Twain E.S. Fence and Gate Replacement Project

No. 0005-23-24

ADDENDUM #1

Date Issued: November 9th, 2023

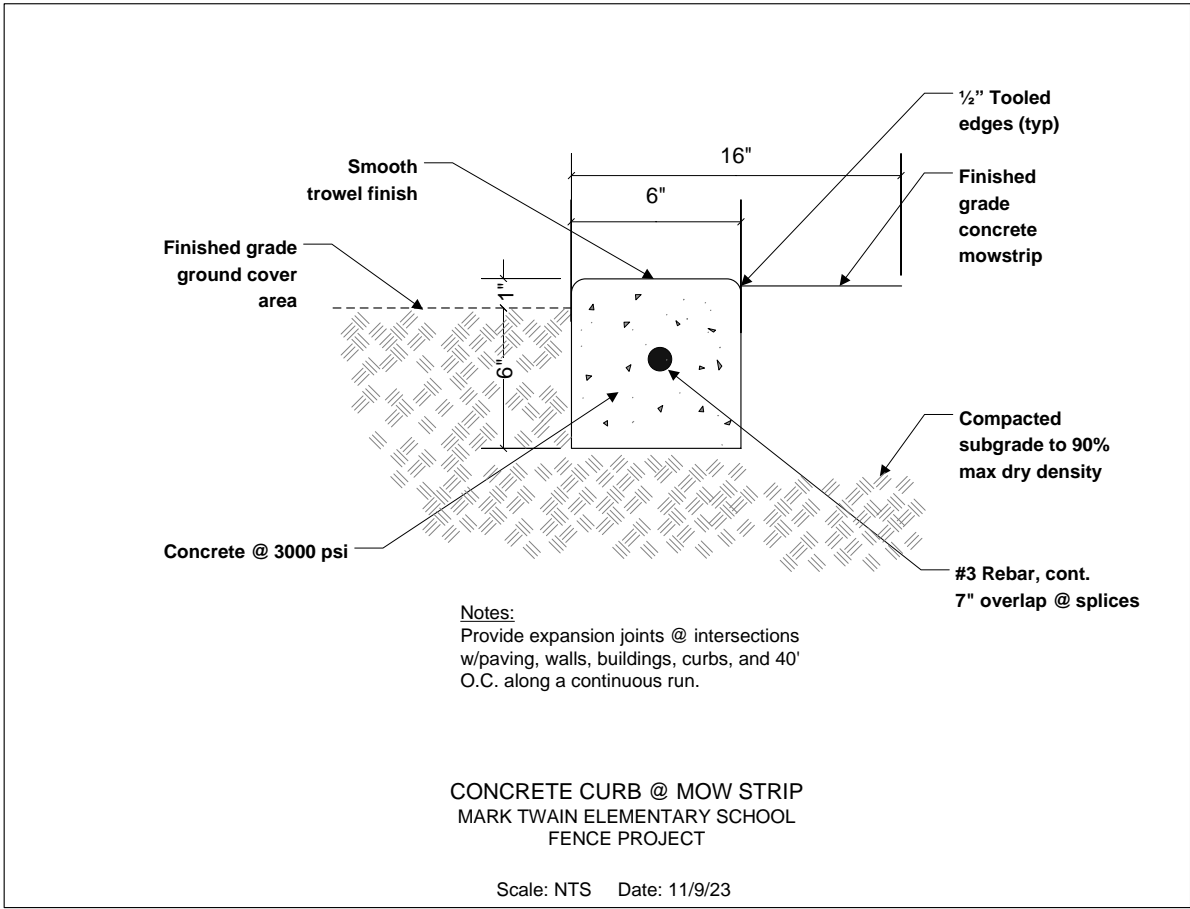
Work will include replacement of fences and gates at the specified areas as shown on the site plan graphic attached to this scope of work document.

Concrete Curb and Mow Strip

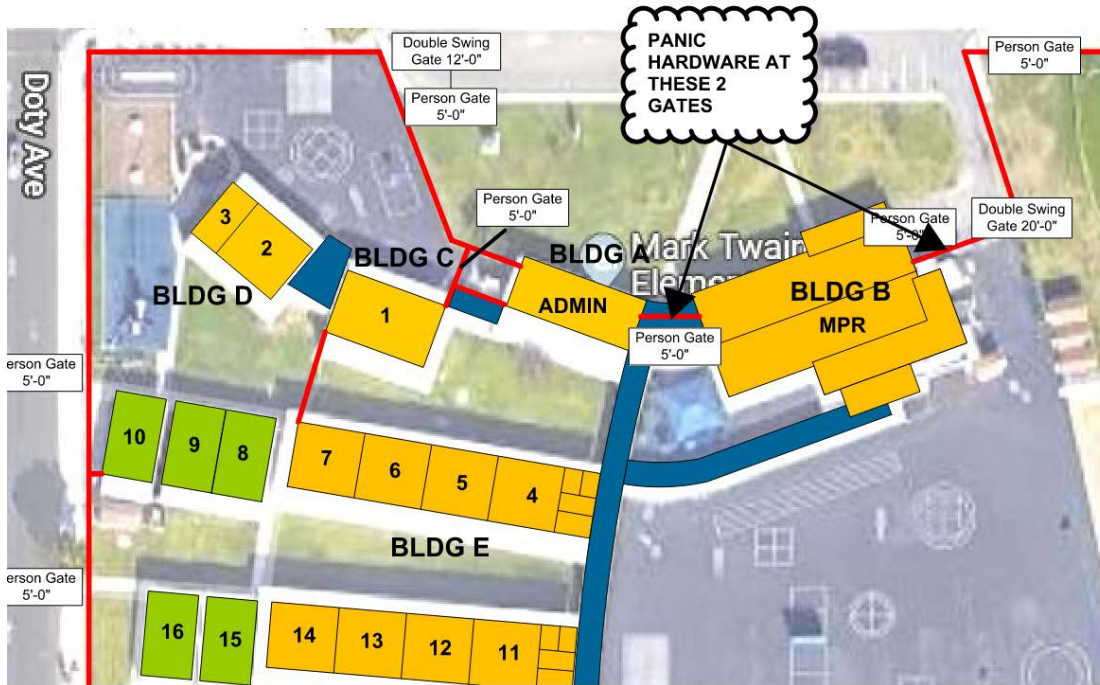
Item C – Add, Curb and Mow Strip Detail

Curb and mow strip detail included in this addendum.

Can the district please provide a construction detail for the concrete mow strip & curb?

Will any rebar reinforcement be required for the concrete mow strip & curb? If so, please indicate the quantity and size of the rebar reinforcement.

See detail included in this addendum.

See detail included in this addendum.

Two Panic Bar Device Gate Locations

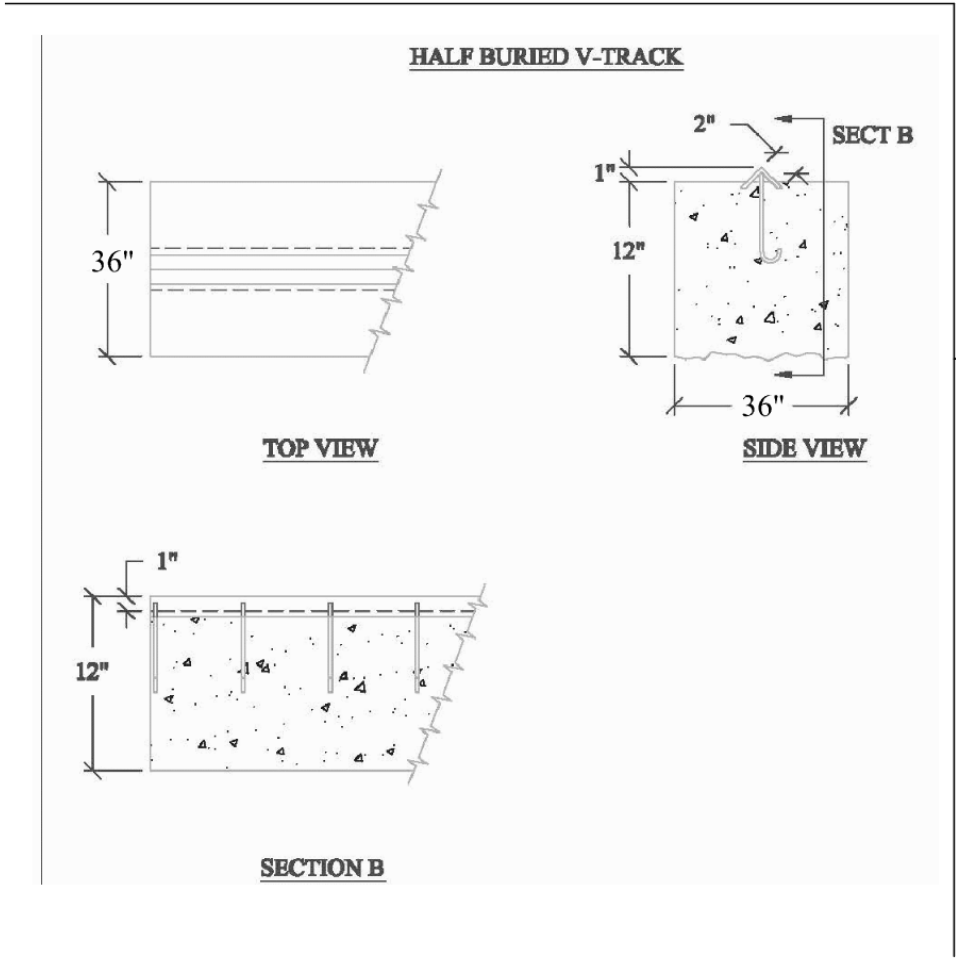
Item D – Add, Panic Bar Gate Device

See map included in this addendum for locations.

Some of the existing walk gate have panic bars, will any new gates require panic hardware? If so, please indicate on the site plan and provide the hardware specifications.

2 gates require panic bar exit devices. **Hardware:** Von Duprin 99 Series 36" Rim Exit Device. See map included in this addendum for locations.
